RE: 3901 Masthead St. NE
Grading & Drainage Plan
Engineer's Stamp Date 9-26-2016 (File: D17D095)

Based upon the information provided in your submittal received 9-26-16, the above referenced plan is approved for Building Permit with the following conditions:

GRADING PLAN - WEST DRIVEWAY

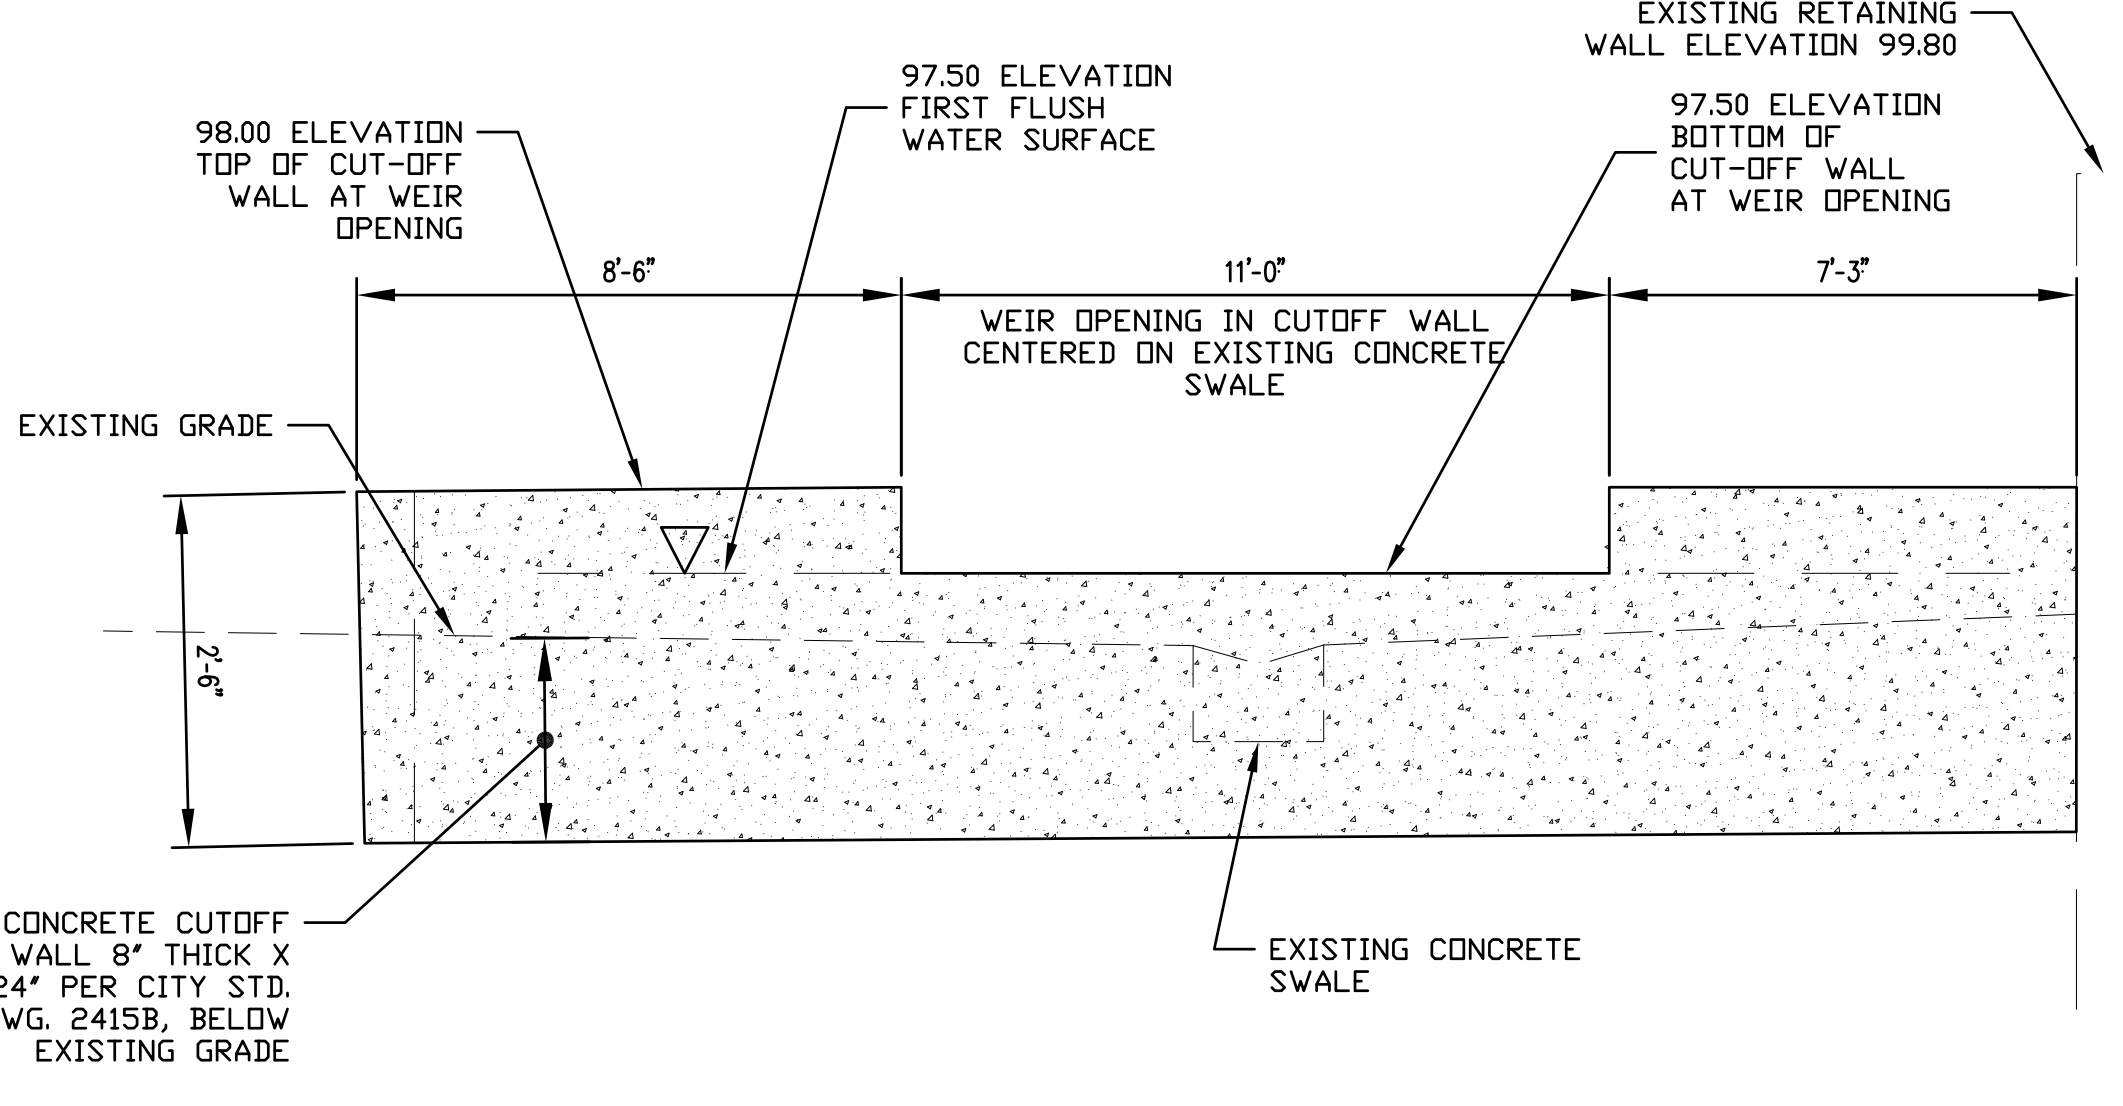
- Keyed Note 5 states that pond side slopes are at 2:1. It infers that all sides are at 2:1, but rip-rap is only shown on 2 sides. All slopes steeper than 3:1 require rip-rap per DPM. Prior to C.O. rip-rap should be on all sides of pond.
- Edit the leader of Keyed Note 3. It is not pointing to the location of the weir, which is on west side of pond.
- Edit Keyed Note 15 to ensure the ESC BMP is implemented before /during construction, but not required once it is built. Please ensure contractor implements the BMP.
